LICENSE No: 24-21362-01

SUBJECT: Response to Conv. Record dated 9-Sep-14 regarding SOP-44

Response to conversation record between ARC and NRC dated 9-Sep-14

SUBJECT: Repair or Replace Hood Exhaust System

Building 300 Roof
Consolidated Duct
RP - Roof Plenum
Do Not Scale -
Schematic Only

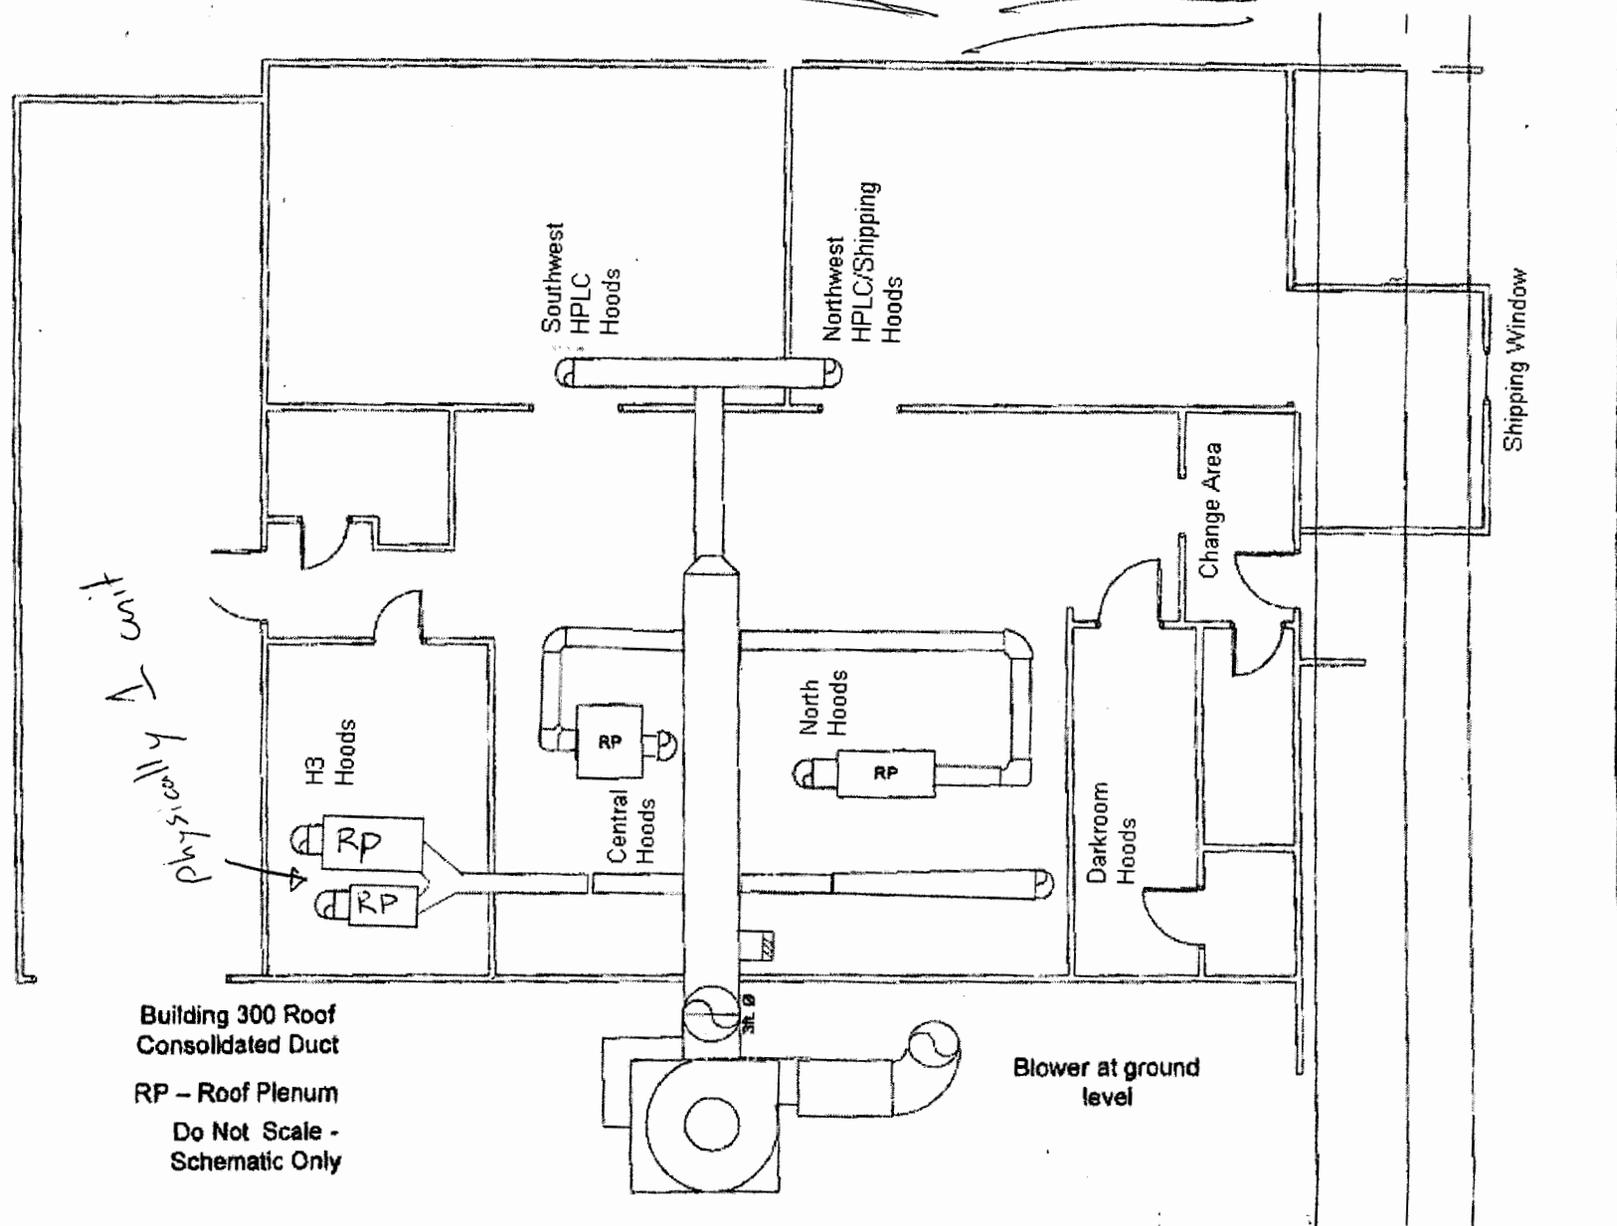
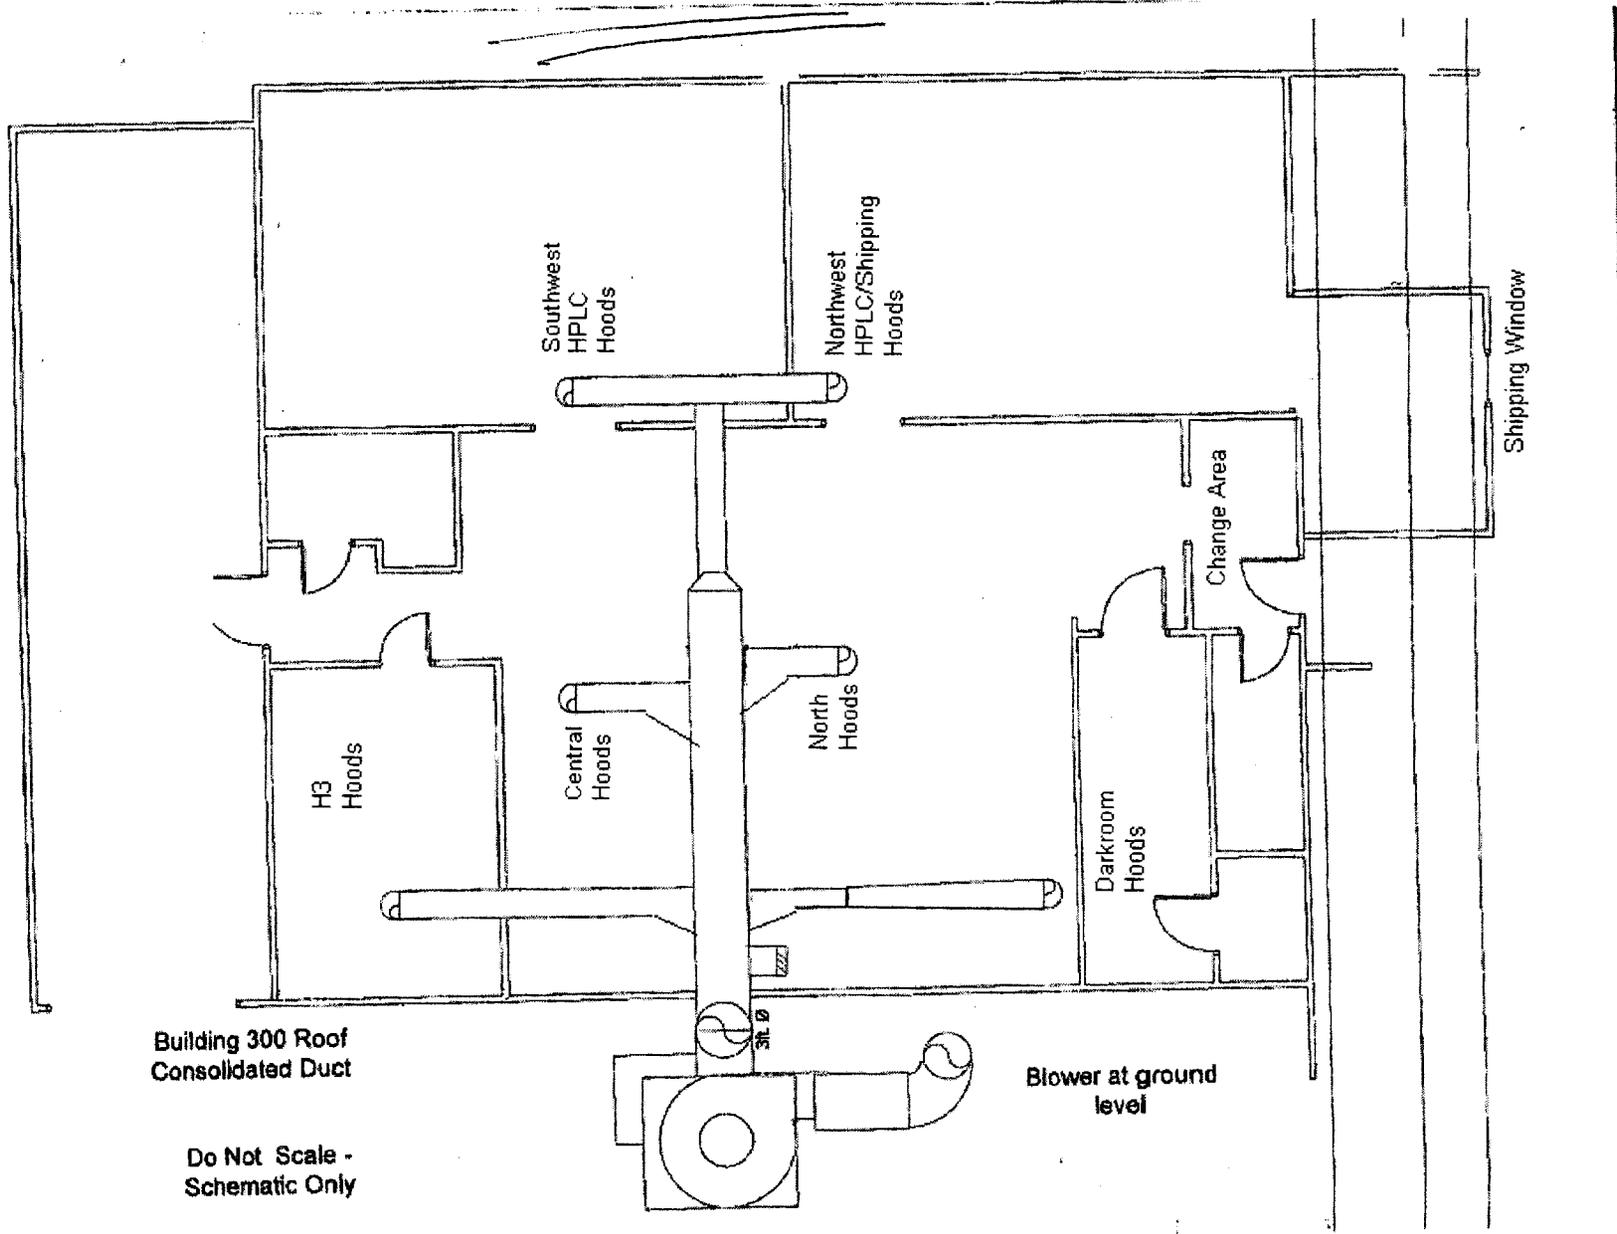
- 2. Submit a current diagram of the exhaust system and identify the areas within the system where the work will be performed. Include a diagram of the proposed revision to the system and identify components that will be replaced, including filtration.**

Response: A diagram of the ductwork before and after the proposed changes has been included in this letter. The filtration boxes are not required and will not be replaced. ARC's most recent dose to the public calculation showed 0.286 mrem in a year.

Components removed: three (3) filter houses, rusted ductwork.

Components added: Four (4) forty-five degree taps that connect the main line with the first four lateral lines. Possibly two (2) more taps at the terminal lines, depending on if they need to be replaced or not.
